[Docket No. 98-NM-323-AD]

#### Airworthiness Directives; Boeing Model 757-200, -200PF, and -200CB Series Airplanes Powered by Rolls-Royce RB211-535C/E4/E4B Turbofan Engines

**ACTION:** Supplemental notice of proposed rulemaking; reopening of comment period.

FIGURE 1

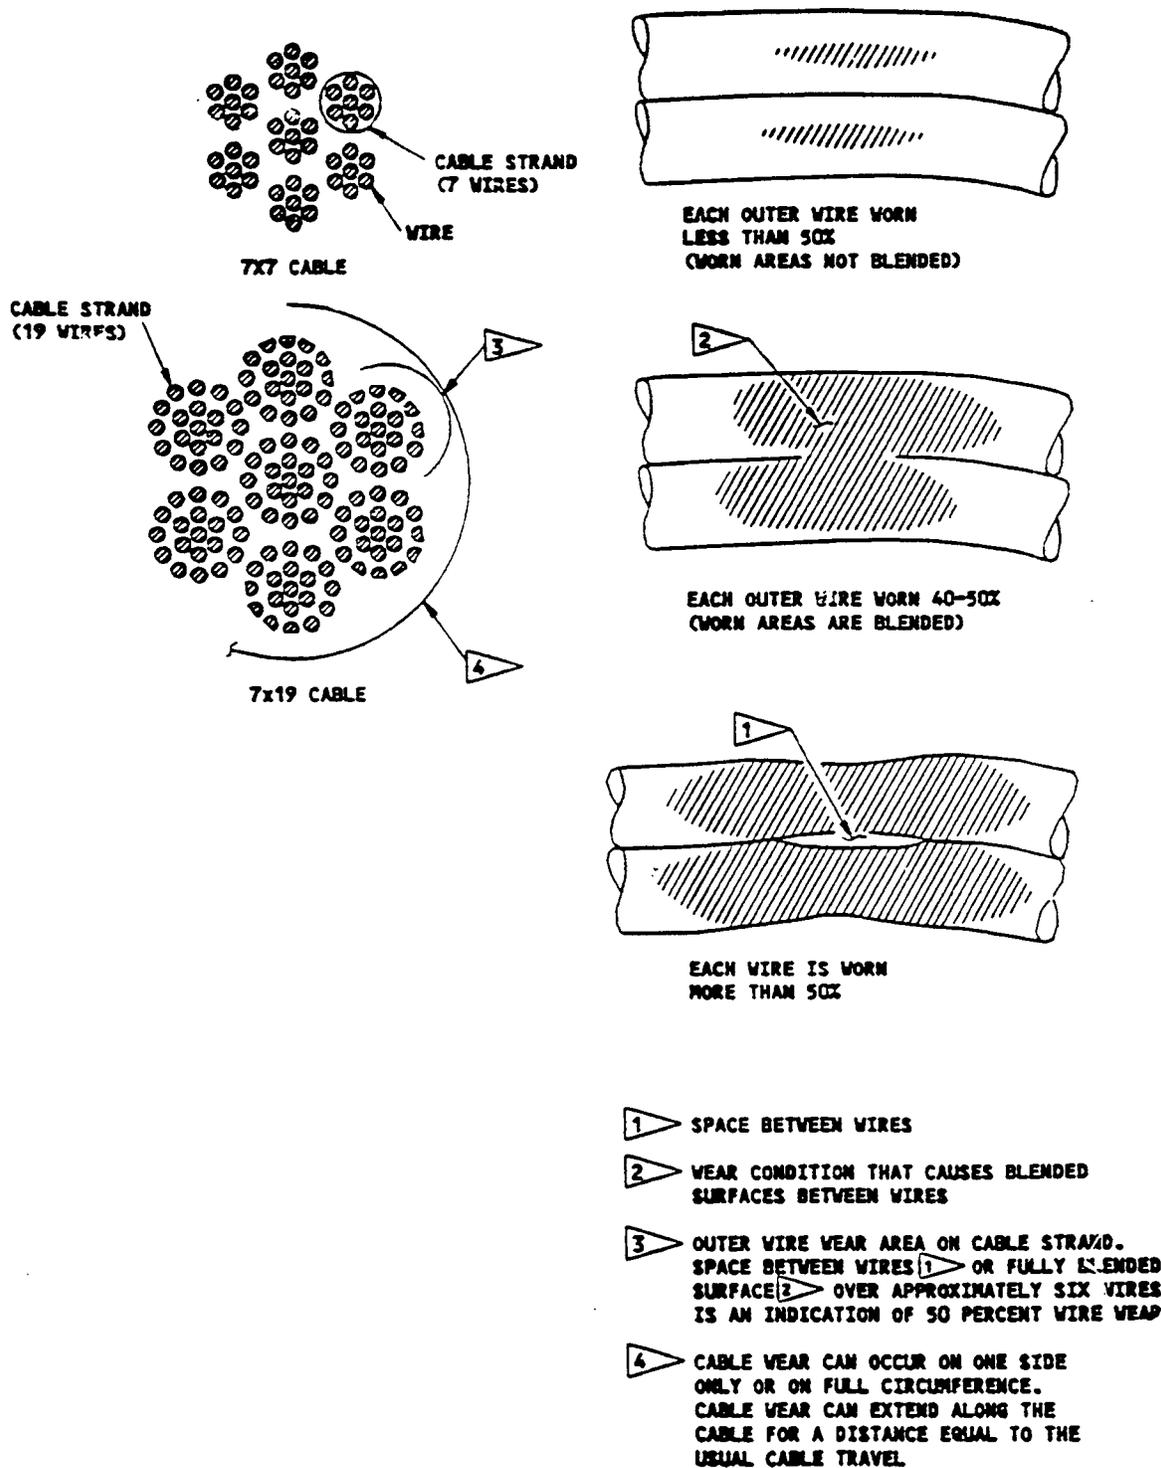
Two commenters request that the "Thrust Control Cable Inspection Procedure," specified in paragraph (a) and described in Appendix 1 of the proposal, be revised to focus on minimizing the possibility of failure of an engine thrust control cable. One of the commenters suggests that the procedure be revised to eliminate all steps that don't contribute to the intent of the AD. The same commenter also suggests that the inspection procedure would be enhanced by adding an inspection of the cable joints.

The FAA concurs with the commenters' request, and the "Thrust Control Cable Inspection Procedure" specified in Appendix 1 of this supplemental NPRM has been revised accordingly.

B. Perform a detailed visual inspection of the cable runs to detect incorrect routing, kinks in the wire rope, or other damage. Replace the cable assembly if:

(1) One cable strand had worn wires where one wire cross section is decreased by more than 40 percent (see Figure 1),
